19 June 2020

Alyce Jeffery
Planning Solutions Team
Camden Council

Re: 2020/2014/P, 6-8 Kemplay Road

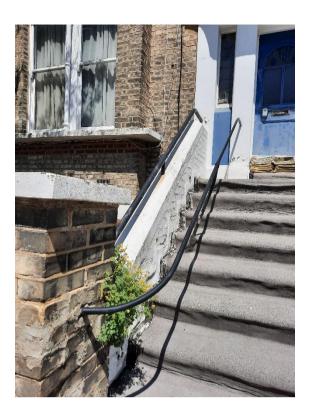
Lengths of 4x2's form make-shift railing in the front, unattractive coping material

Decorative window railing is missing on the left-hand side

Hand railings at front fail to enhance the entrance; the broad steps are a prominent feature of the building

A green space could be created in the front garden for tenants and to contribute to biodiversity
